CITY PLANNING COMMISSION

- APPLICATION:**
- A. Certify Final E.I.R.
 - B. Amend 1986 South Sacramento Community Plan Land Use Designation from Residential-Office to General Commercial for 14+ acres.
 - C. Rezone 14+ vacant acres from Office Building-Review (OB-R) zone to General Commercial-Review (C-2-R) zone
 - D. Plan Review of a 118,820+ sq. ft. commercial building with truck dock and tire installation facilities

LOCATION: Southwest corner of Mack Road and Franklin Boulevard

APPLC. NO. P87-448 **MEETING DATE** May 19, 1988 **ITEM NO.** 2

EXHIBIT D SITE PLAN

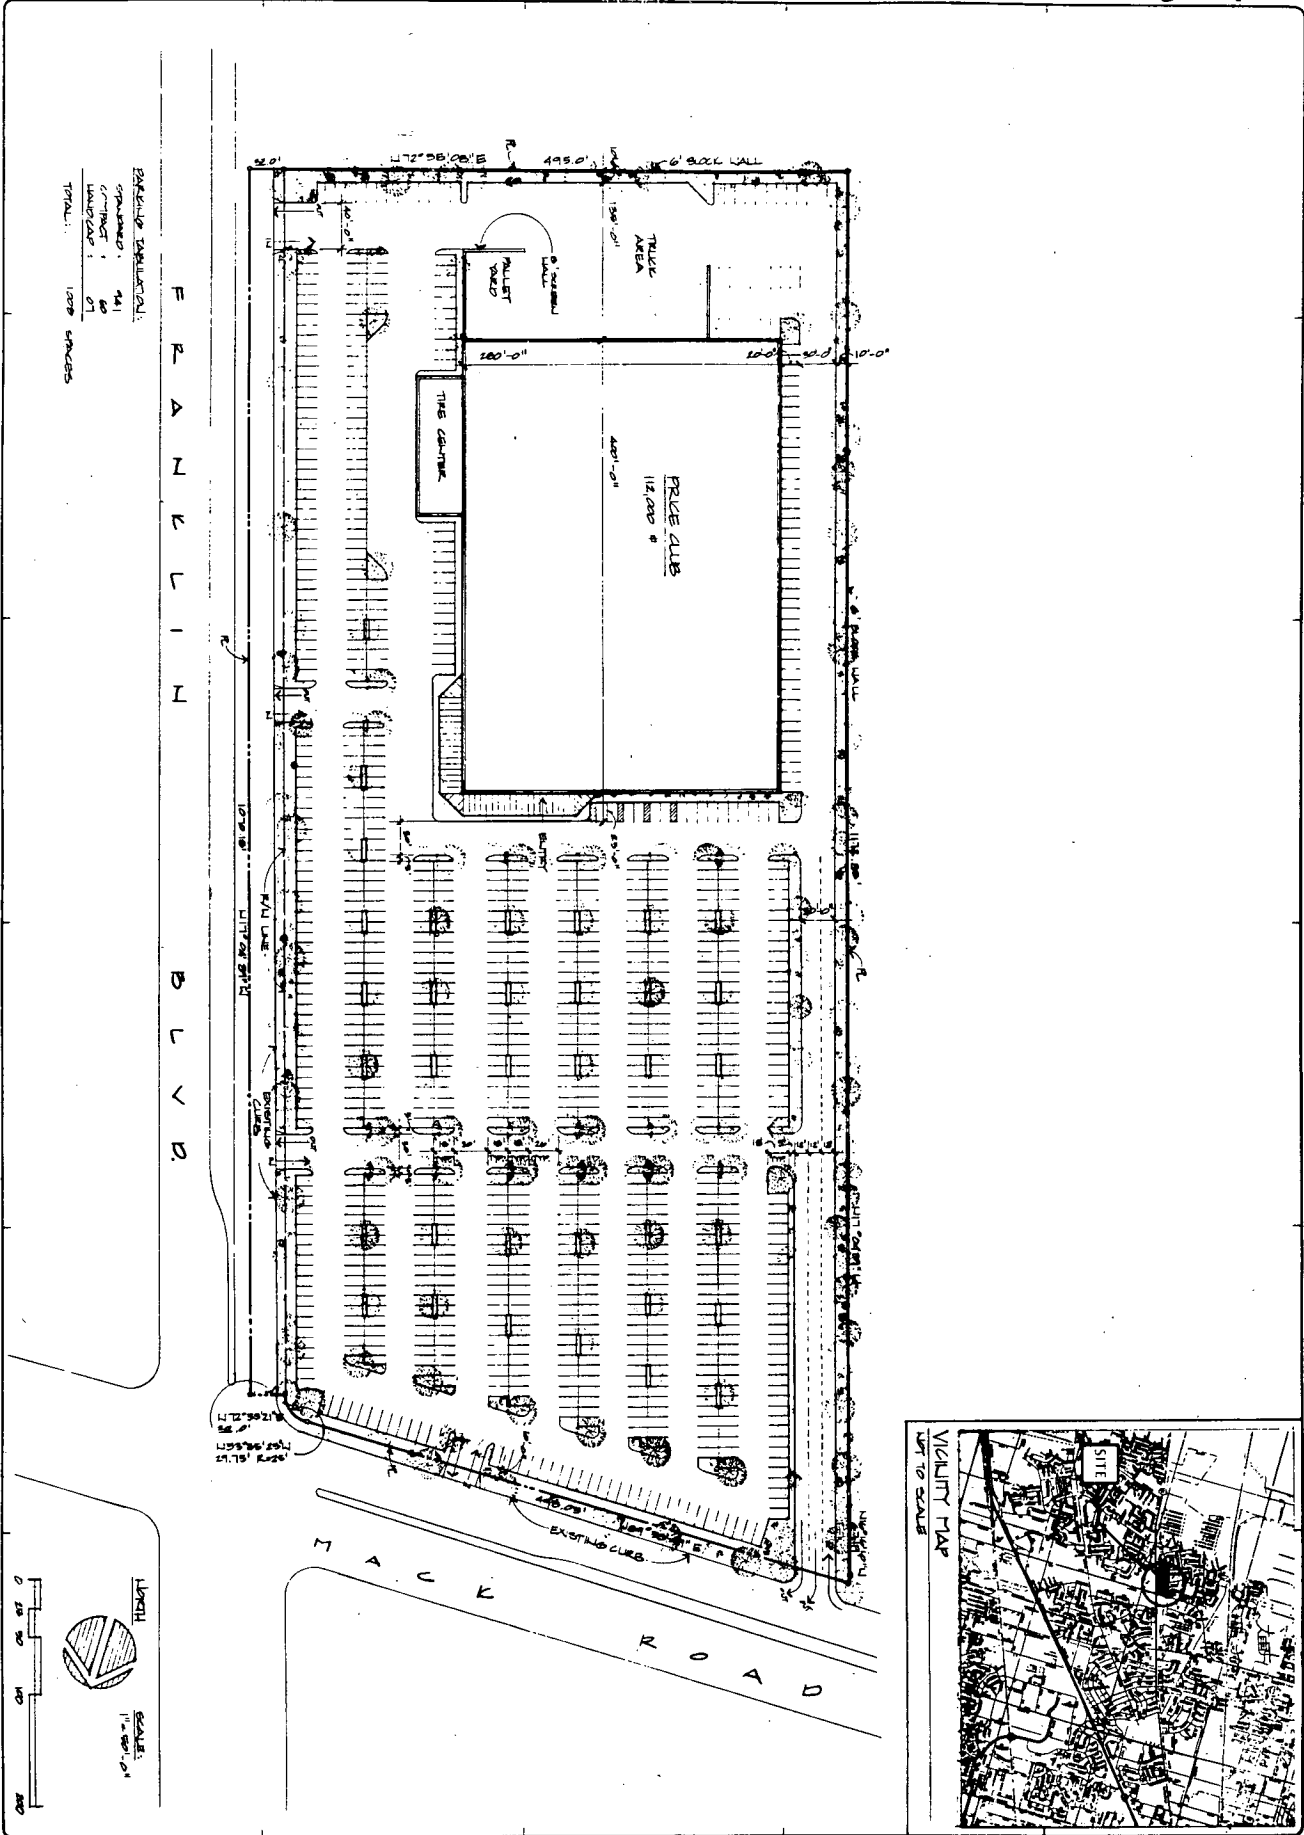
1. Noise impacts on adjacent residential homes from the loading area on the south side of the building. To mitigate this impact, the E.I.R. suggested two solutions and two additional solutions were developed by staff.

- a. Building a 10 foot wall on the property line (E.I.R. solution). Staff feels this is not acceptable due to the negative visual impact on the adjacent homes.

- b. Move the building to the northern portion of the site (E.I.R. solution). Staff and applicant feel this is not acceptable since it proposes an awkward relationship of the parking area to the main entrance. Further, the loading area would also conflict with auto/pedestrian circulation.

- c. Place a high screening wall around the loading area (staff solution). This has been used in other similar situations.
 - d. Enclose the loading area (staff solution). This appears to be the most effective solution which the Price Company indicates they have used in another site where more flexibility existed.

Staff has reviewed the four alternatives and supports redesign to alternative 'c' or 'd' subject to review and approval by the Planning Director.

EXHIBIT E ELEVATIONS

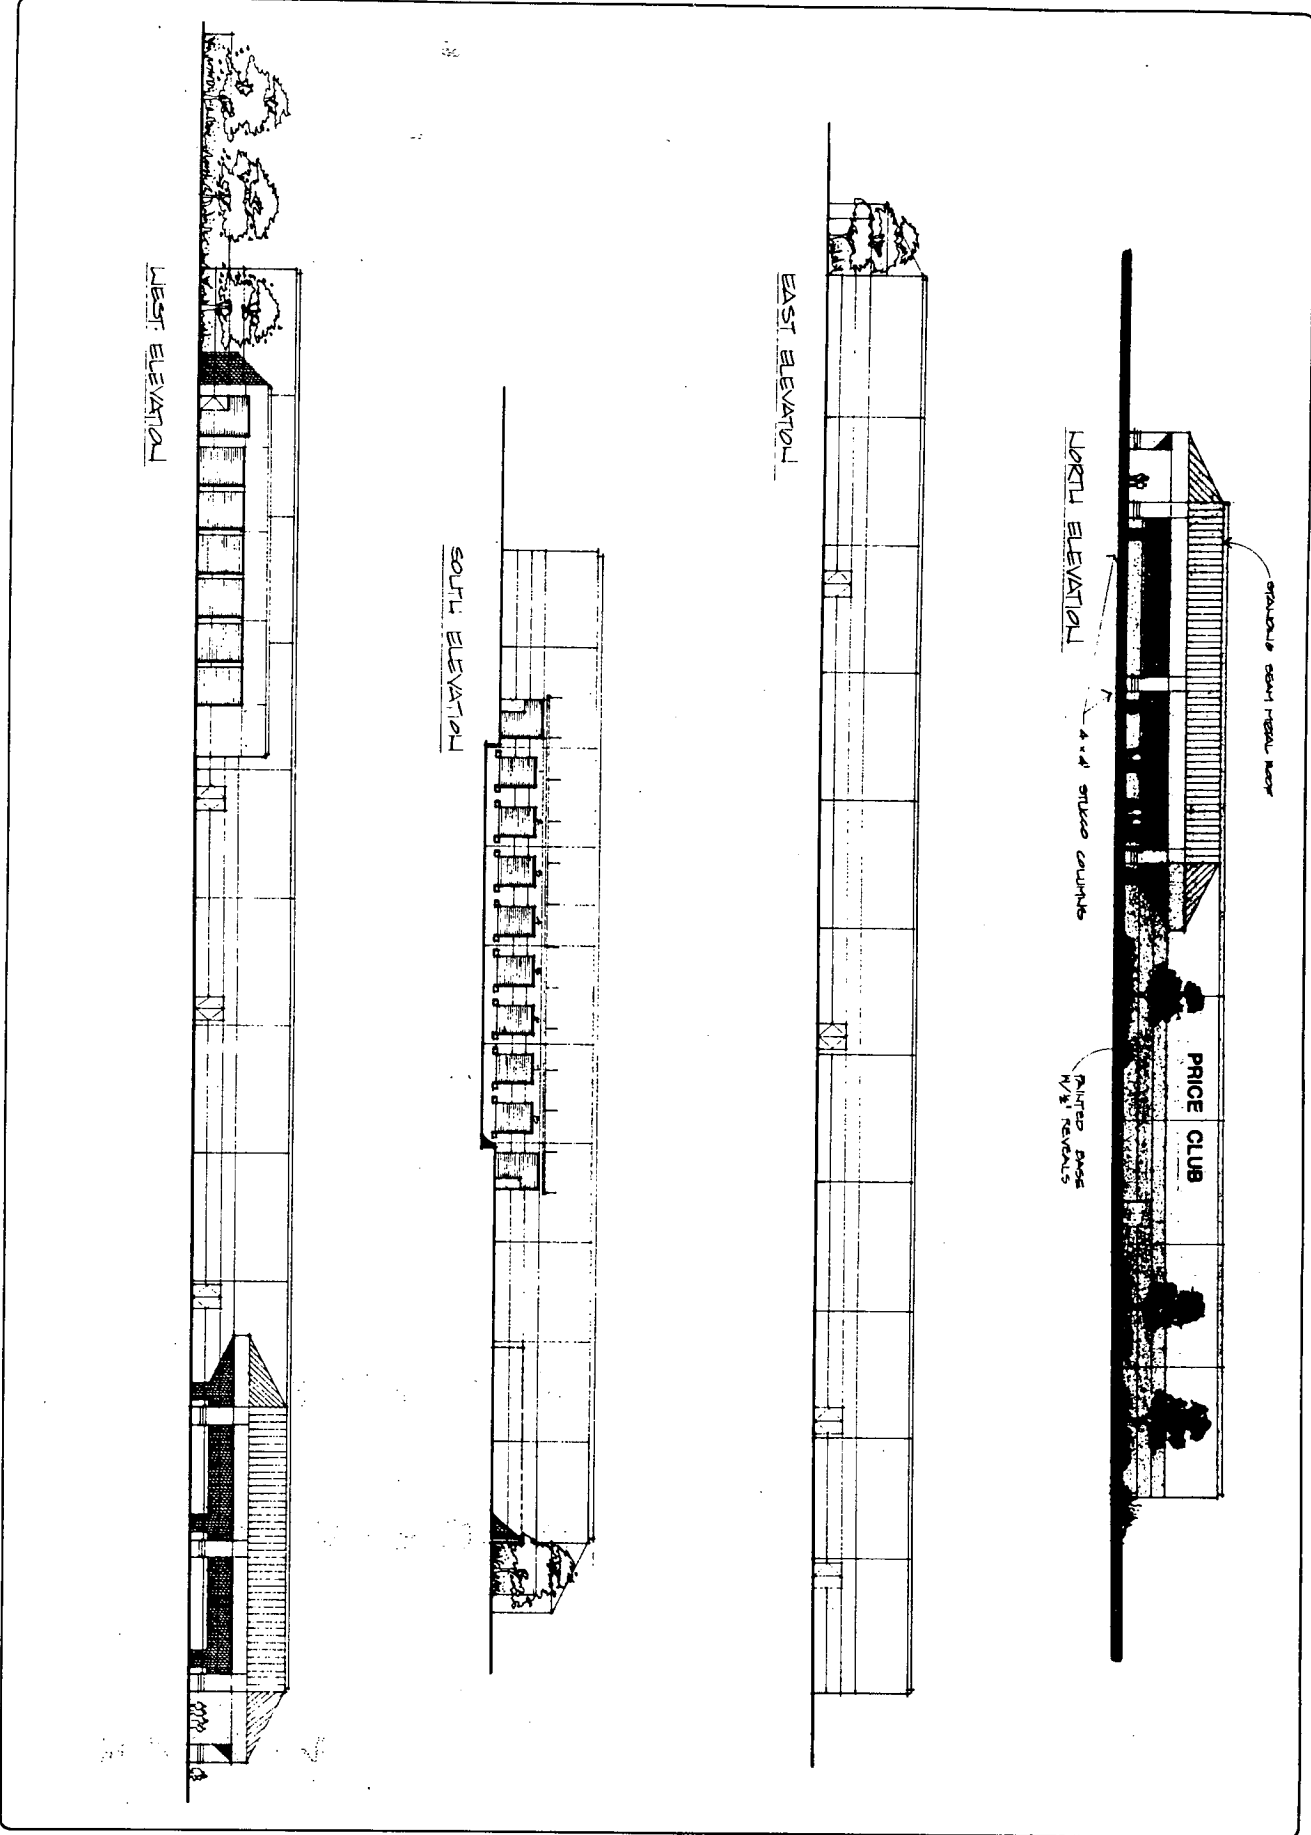
6. Building elevations for the south elevation have not been reviewed by staff. The applicant has modified the exterior elevations to provide more variety and relief on the east, west and north elevations from the original submittal. Staff recommends several conditions to enhance the exterior subject to Planning Director's review and approval.

1. The applicant shall revise the building elevations to show a covered canopy extending along the north and east elevation which is compatible with the design of the building. Material and design of the canopy shall be reviewed and approved by the Planning Director.
2. A sidewalk adjacent to the building shall be observed so that customers carrying tires to the tire shop do not require access through the parking lot or vehicle access lanes.
3. The applicant shall provide color samples of materials to be used on the building at the time of building permit application.
5. The south elevation, including the loading dock area shall be reviewed and approved by the Planning Director. The formliner element of the west elevation shall be continued to the south elevation.
